PD 1019

DEPARTMENT OF HOUSING AND ECONOMIC DEVELOPMENT
CITY OF CHICAGO

June 4, 2013

**Re: Administrative Relief request for Institutional Planned Development No. 1019
St. Joseph Hospital**

West Elevation

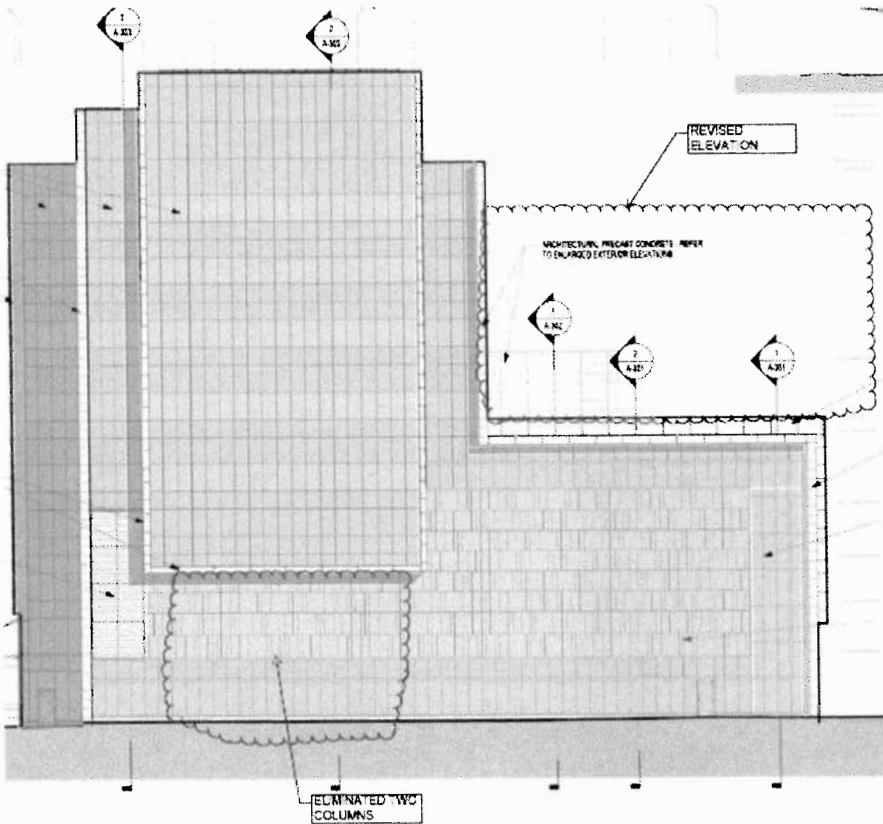
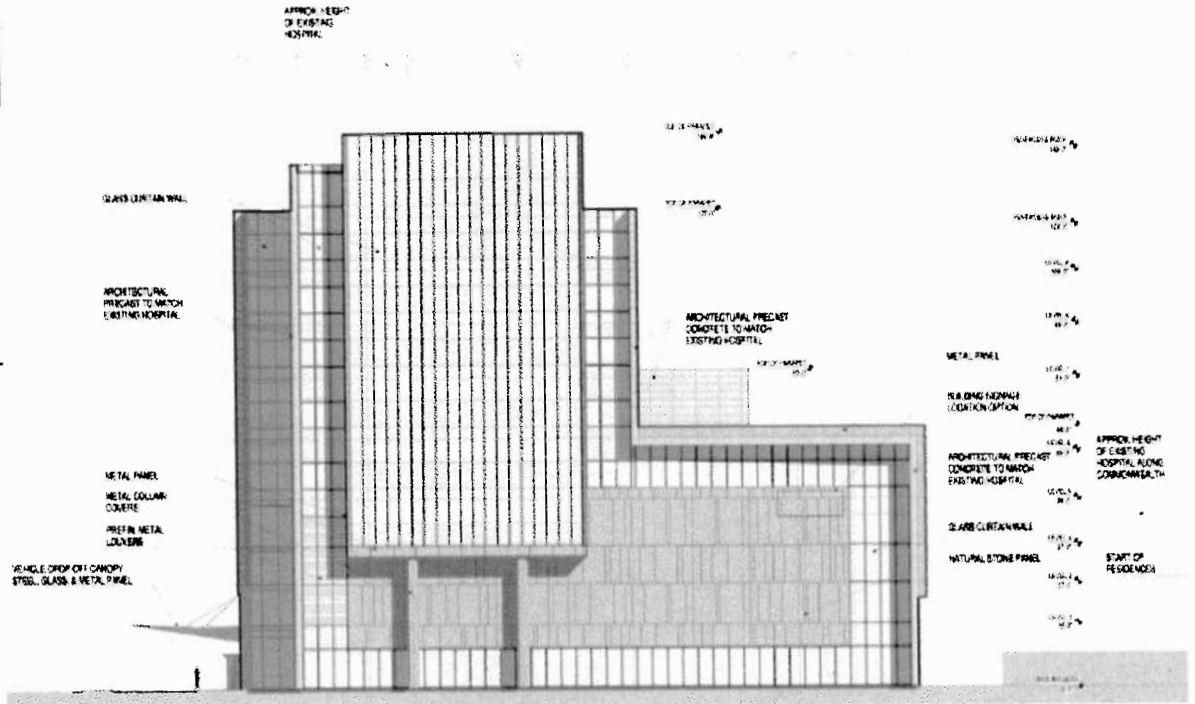
1. The elimination of two vertical columns on the West Elevation.
2. The shifting of the sky bridge approximately 19 feet to the south so that it aligns with the existing hospital corridor on the East Elevation.
3. The addition of overhead doors on the entrance of the parking garage on the East Elevation of the ground floor, in order to provide security for the building.
4. The elimination of 13 parking spaces from the parking garage due to the addition of a corridor in the building. The PD requires a minimum of 1,150 parking spaces upon completion of the proposed building. The existing and proposed parking spaces are as follows: Sub area 1 - 756 spaces existing, no change proposed; Sub area 2 - 187 existing

East Elevation

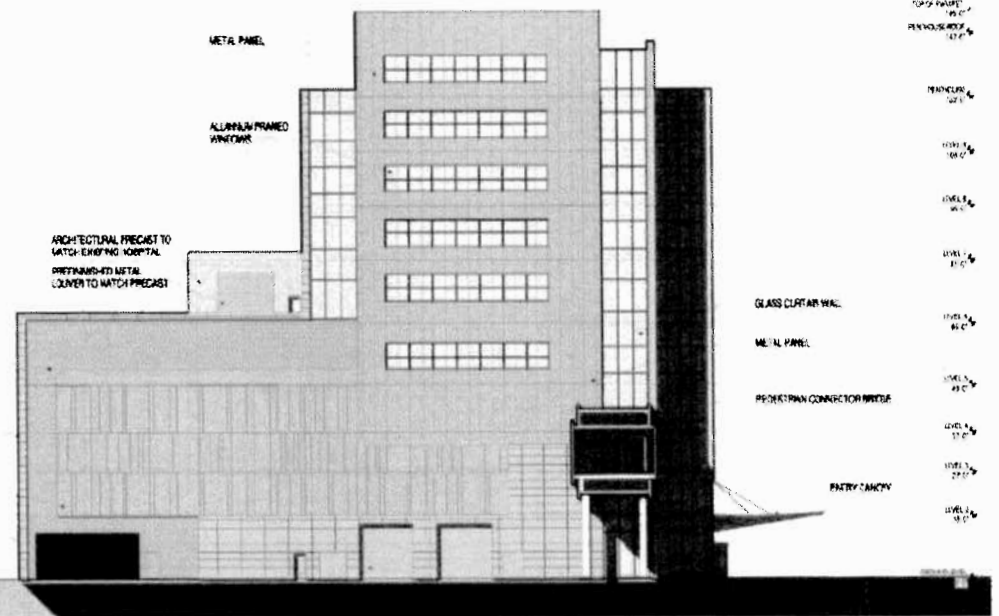
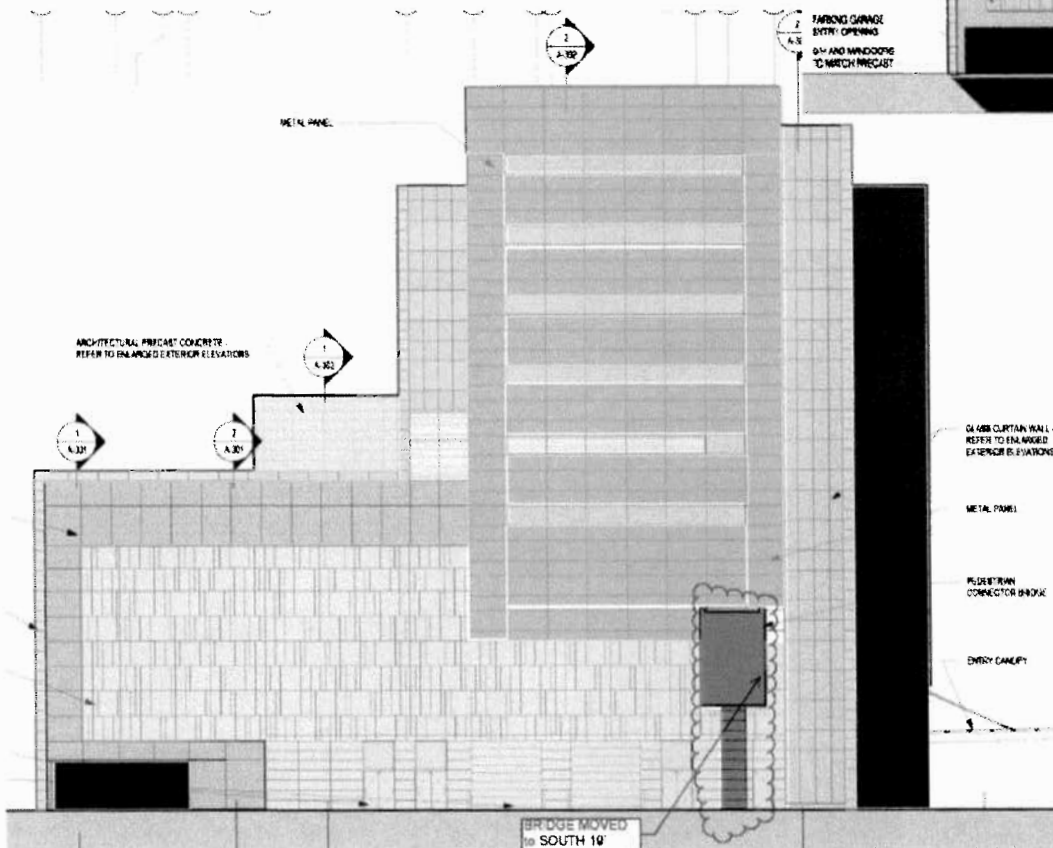
BRIDGE MOVED
to SOUTH 10

Level 3-Parking

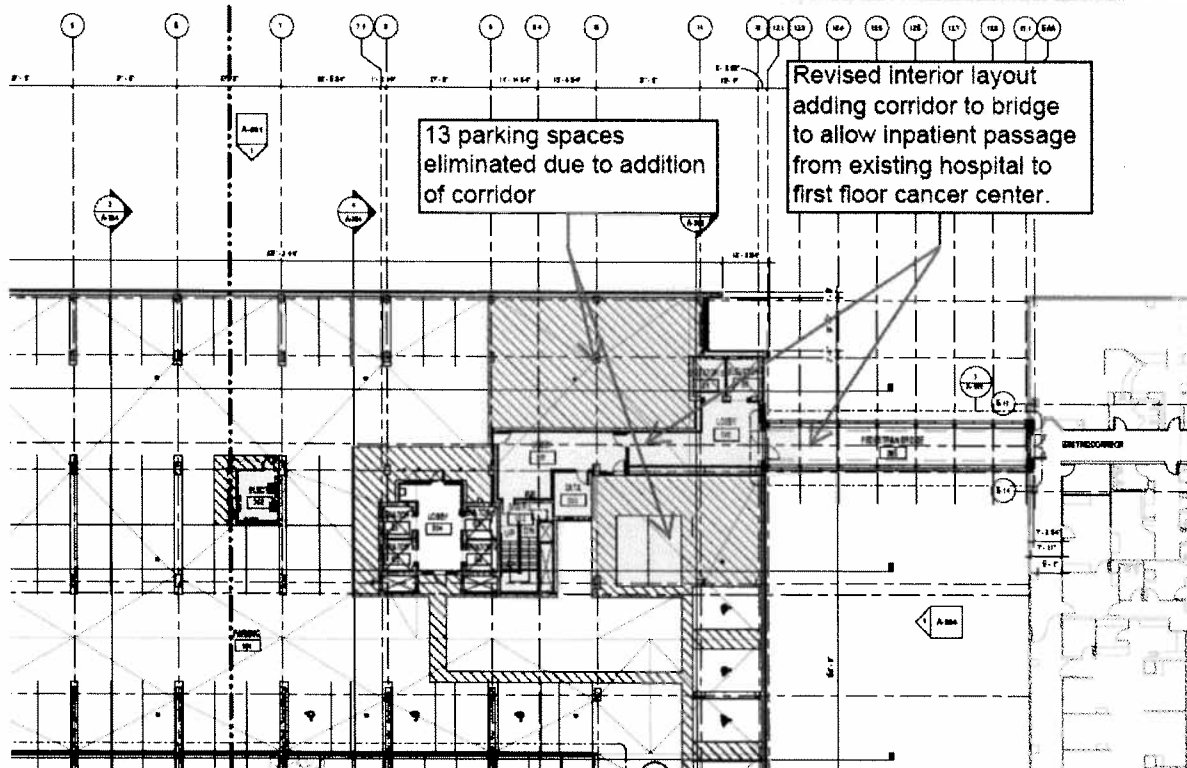
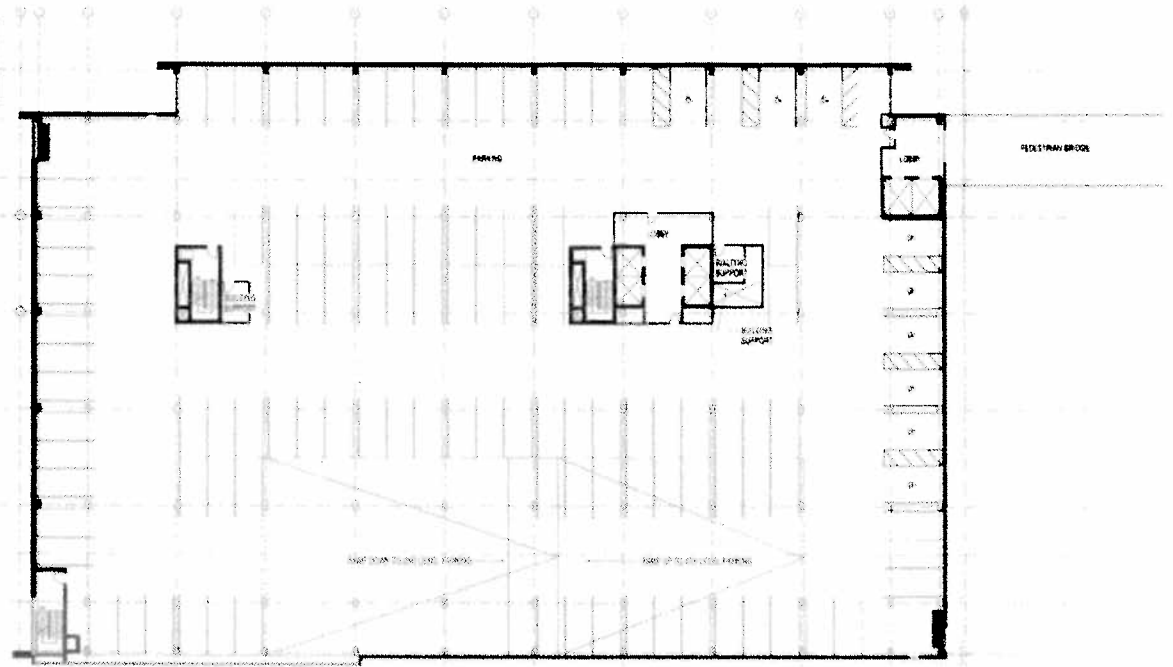
13 parking spaces eliminated due to addition of corridor

Revised interior layout adding corridor to bridge to allow inpatient passage from existing hospital to first floor cancer center.

Landscape Plan at Ground (New)

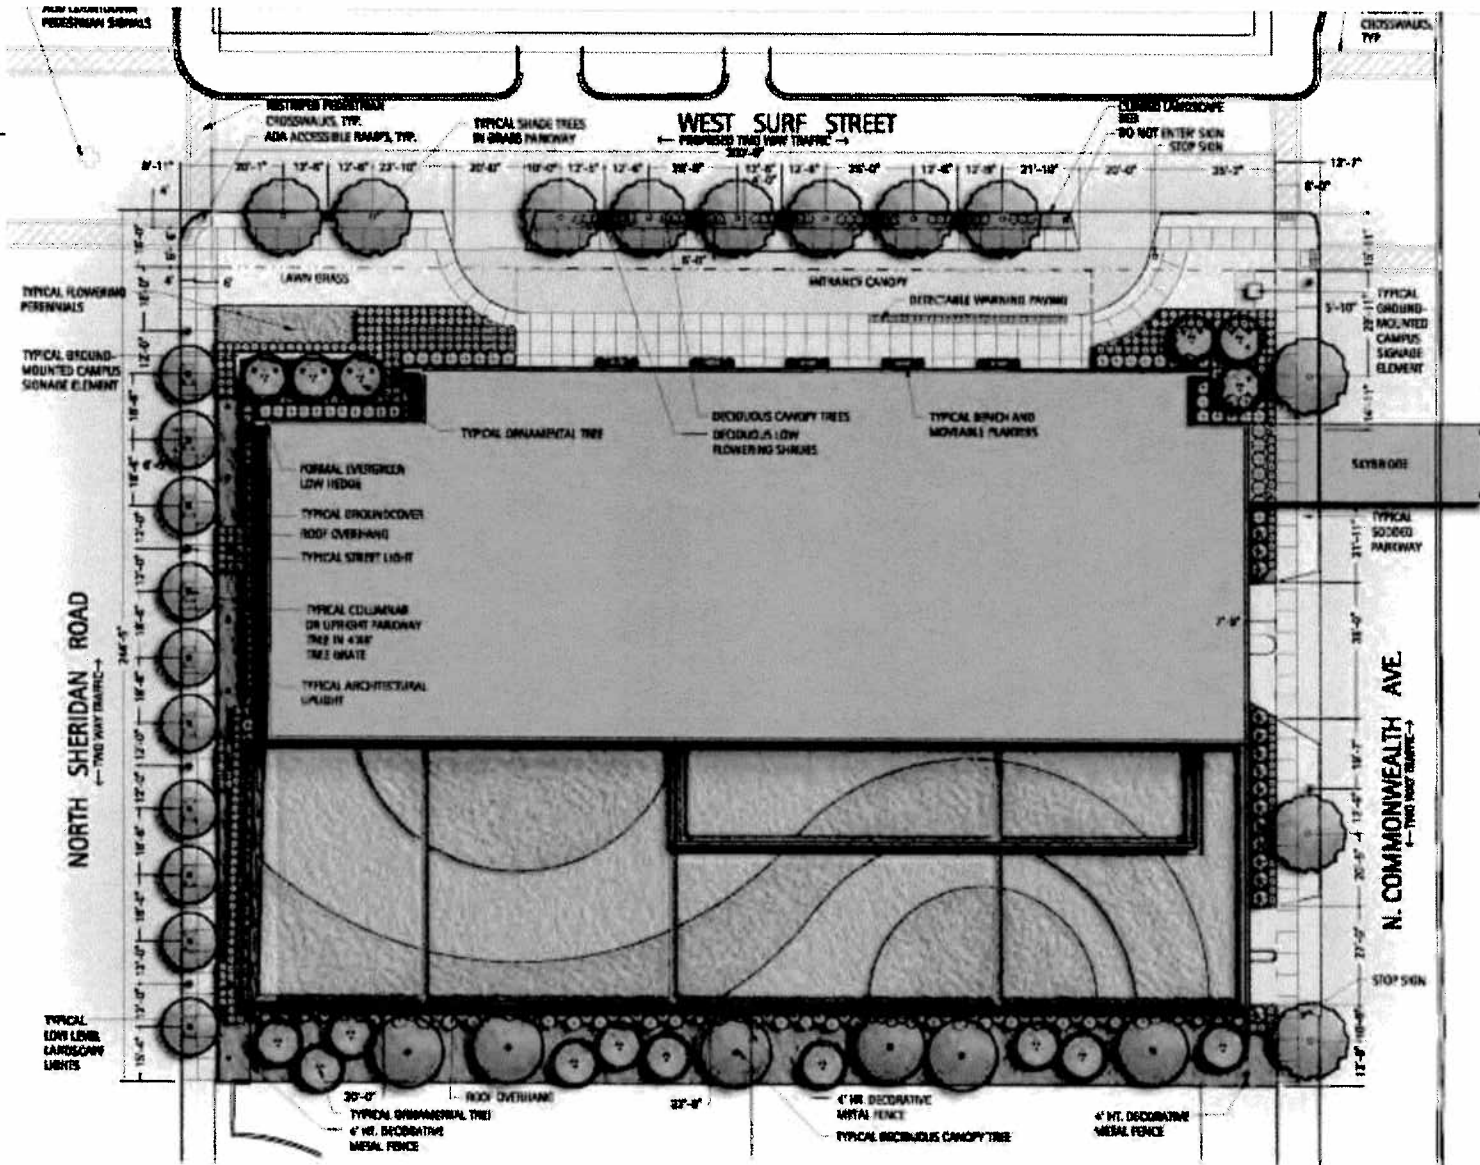
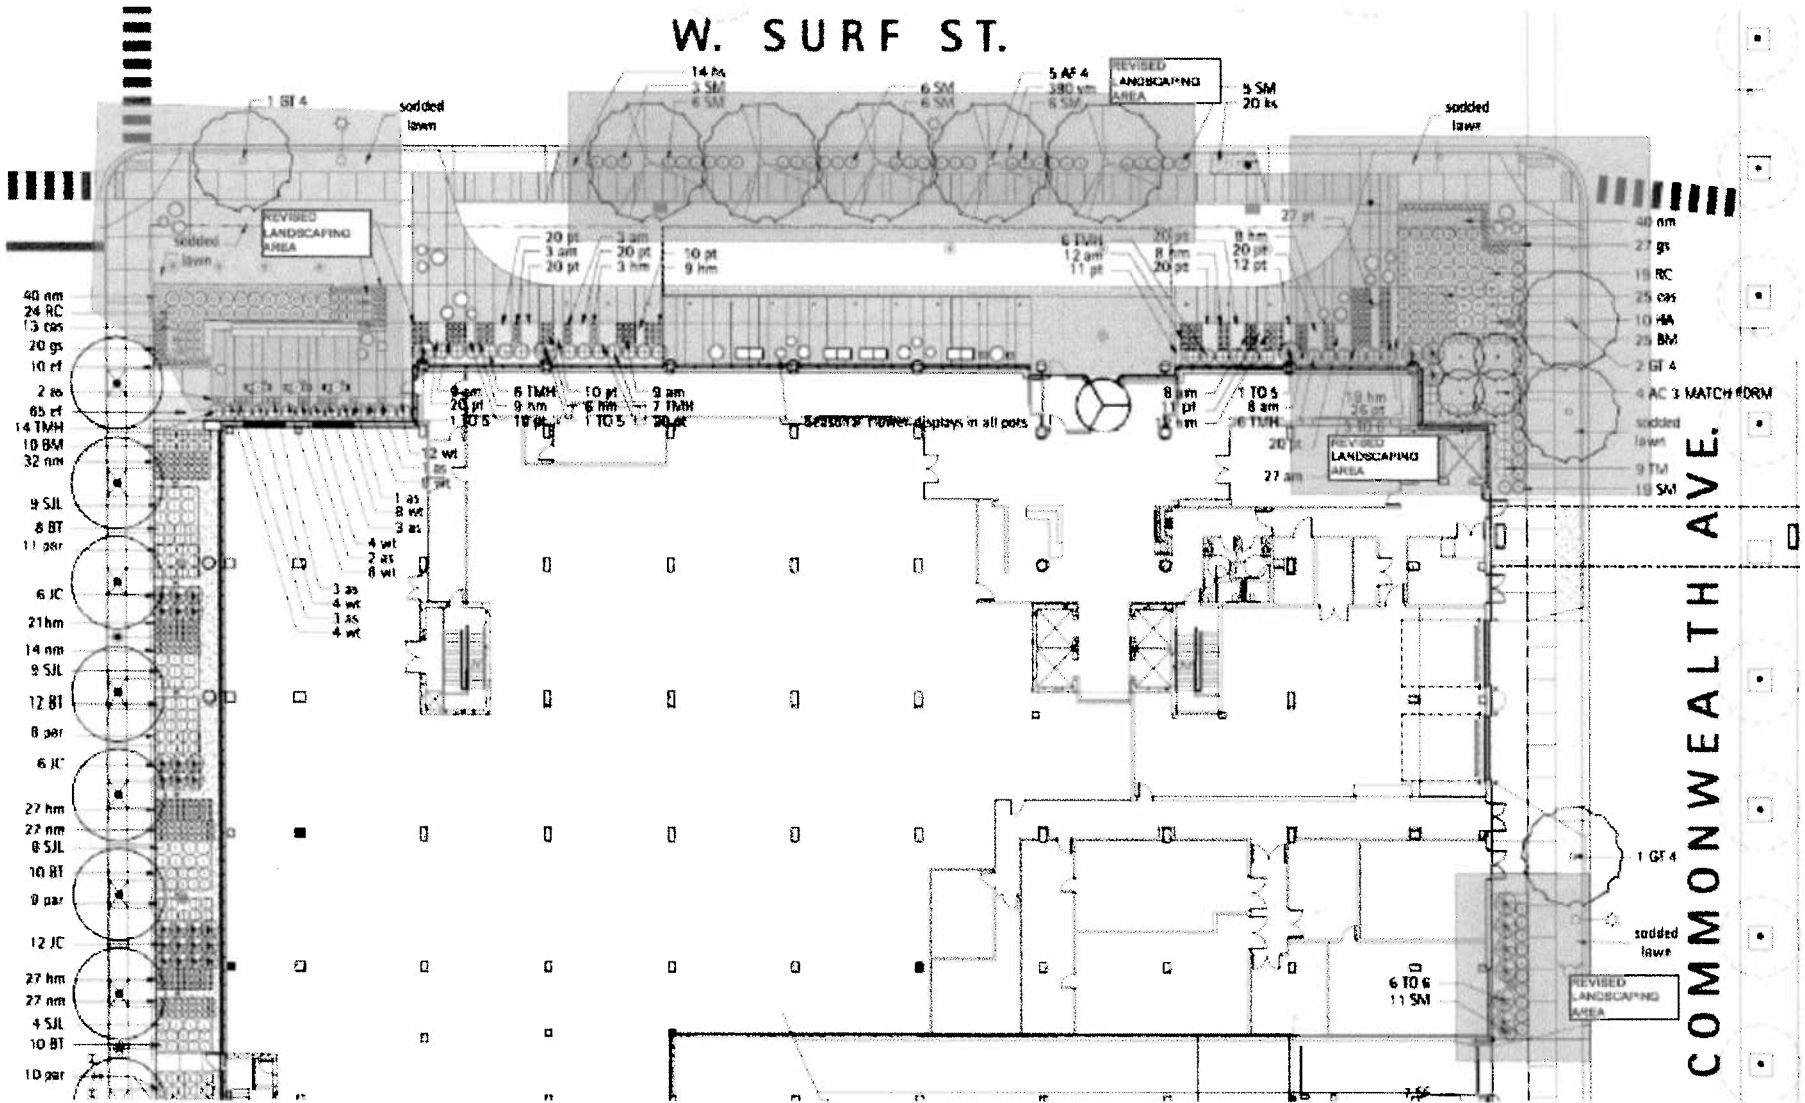
5. Landscaping revisions as follows: one parkway tree has been eliminated from N. Sheridan Rd., two trees have been eliminated from W. Surf St., one tree has been added to N. Commonwealth Ave., interior landscaping has been adjusted (adding plantings under the sky bridge, adding a seating area toward the northwest portion of the lot, and other slight modifications) and modifications to the landscaping south of the building.
6. An increase in the green roof from approximately 41.9% + ASHRAE to 75% + LEED Silver certification, in order to accommodate the City of Chicago's Green Building Permit process. (On April 20, 2011, an administrative relief was approved which included an increase in the green roof from 26% to 41%).
